Re: Revisions to Bike Map

BAC RECOMMENDATIONS (D R A F T) CITY BICYCLE NETWORK CITY OF CALISTOGA

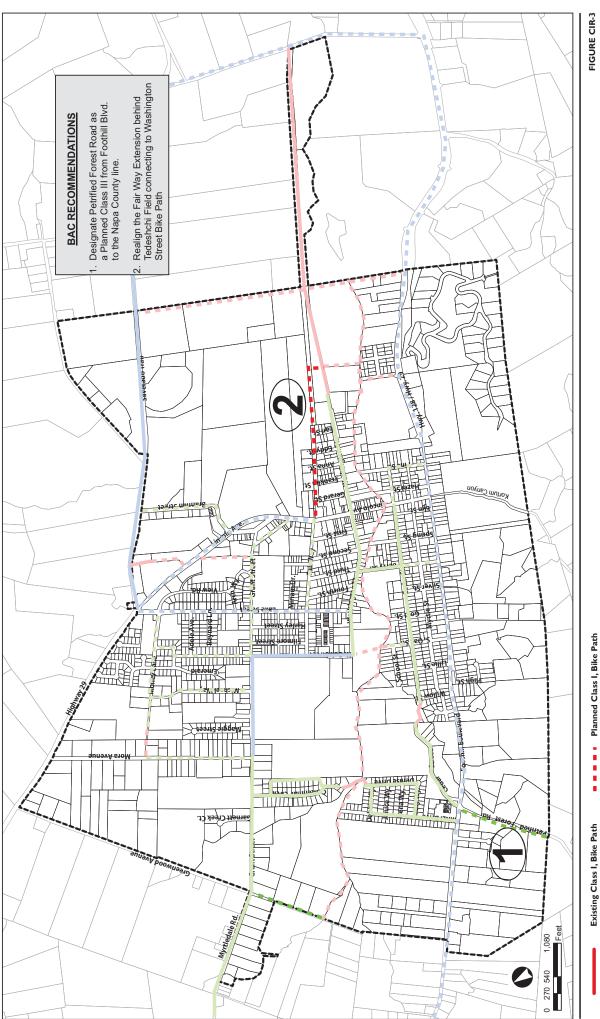
The group recommends that Petrified Forest road be designated as a future Class III bike path because of the presence of the newly built Highland Christian Church with its school. When the needed improvements are made to the road, parents and children will be able to bike to the facility safely. Additionally, a Class III bike path will improve the safety of cyclists using Petrified Forest Road when entering or exiting the popular 'Franz Valley Loop.' One final benefit is that a Class III bike path will enhance bicycle route connectivity between Napa and Sonoma counties.

The group also recommends that the Fair Way extension on the map meet the current Washington Street Bike Path with an alignment behind the Tedeschi Field. This will eliminate the segment of the down-valley segment of Fair Way that parallels the existing Class I bike path.
